SUNDRY NOTICES AND REPORTS ON WELLS
Do not use this form for proposals to drill or to re-enter an abandoned well. Use form 3160-3 (APD) for such proposals.

8. Well Name and No.
TRIONYX 6 FED 11H

Devon Energy Production Company, L.P. respectfully requests to run a FMC multibowl wellhead system on the Trionyx 6 Fed 11H.

**PECOS DISTRICT
CONDITIONS OF APPROVAL**

CONTINGENCY MODE

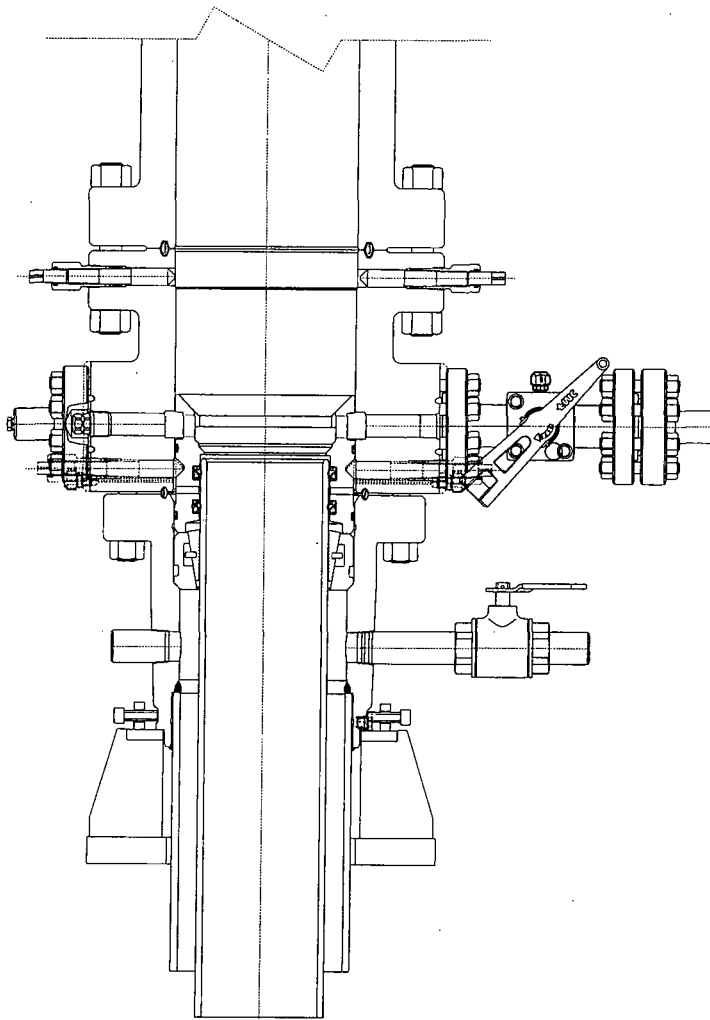
Devon Energy proposes to run a FMC multibowl wellhead system. A multibowl wellhead is being used. The BOP will be tested per Onshore Order #2 after installation on the surface casing which will cover testing requirements for a maximum of 30 days. If any seal subject to test pressure is broken the system must be tested. Devon proposes using a multi-bowl wellhead assembly (FMC Uni-head). This assembly will only be tested when installed on the surface casing. Minimum working pressure of the blowout preventer (BOP) and related equipment (BOPE) required for drilling below the surface casing shoe shall be 3000 (3M) psi.

Wellhead will be installed by FMC's representatives. If the welding is performed by a third party, the FMC's representative will monitor the temperature to verify that it does not exceed the maximum temperature of the seal. FMC representative will install the test plug for the initial BOP test. FMC will install a solid steel body pack-off to completely isolate the lower head after cementing intermediate casing. After installation of the pack-off, the pack-off and the lower flange will be tested to 5M, as shown on the attached schematic. Everything above the pack-off will not have been altered whatsoever from the initial nipple up. Therefore the BOP components will not be retested at that time.

If the cement does not circulate and one inch operations would have been possible with a standard wellhead, the well head will be cut and top out operations will be conducted. Devon will pressure test all seals above and below the mandrel (but still above the casing) to full working pressure rating.

Devon will test the casing to 0.22 psi/ft or 1500 psi, whichever is greater, as per Onshore Order #2. After running the 13-3/8" surface casing, a 13-5/8" BOP/BOPE system with a minimum rating of 3M will be installed on the FMC Uni-head wellhead system and will undergo a 250 psi low pressure test followed by a 3,000 psi high pressure test. The 3,000 psi high and 250 psi low test will cover testing requirements a maximum of 30 days, as per Onshore Order #2. If the well is not complete within 30 days of this BOP test, another full BOP test will be conducted, as per Onshore Order #2. After running the 9-5/8" intermediate casing with a mandrel hanger, the 13-5/8" BOP/BOPE system with a minimum rating of 3M will already be installed on the FMC Uni-head. The pipe rams will be operated and checked each 24 hour period and each time the drill pipe is out of the hole.

These tests will be logged in the daily driller's log. A 2" kill line and 3" choke line will be incorporated into the drilling spool below the ram BOP. In addition to the rams and annular preventer, additional BOP accessories include a kelly cock, floor safety valve, choke lines, and choke manifold rated at 5,000 psi WP. Devon requests a variance to use a flexible line with flanged ends between the BOP and the choke manifold (choke line). The line will be kept as straight as possible with minimal turns.

3. **Operator has proposed a multi-bowl wellhead assembly. This assembly will only be tested when installed on the surface casing. Minimum working pressure of the blowout preventer (BOP) and related equipment (BOPE) required for drilling below the surface casing shoe shall be 3000 (3M) psi.**

- a. Wellhead shall be installed by manufacturer's representatives, submit documentation with subsequent sundry.
 - b. If the welding is performed by a third party, the manufacturer's representative shall monitor the temperature to verify that it does not exceed the maximum temperature of the seal.

- c. Manufacturer representative shall install the test plug for the initial BOP test.
 - d. Operator shall perform the intermediate casing integrity test to 70% of the casing burst. This will test the multi-bowl seals.

- e. If the cement does not circulate and one inch operations would have been possible with a standard wellhead, the well head shall be cut off, cementing operations performed and another wellhead installed.
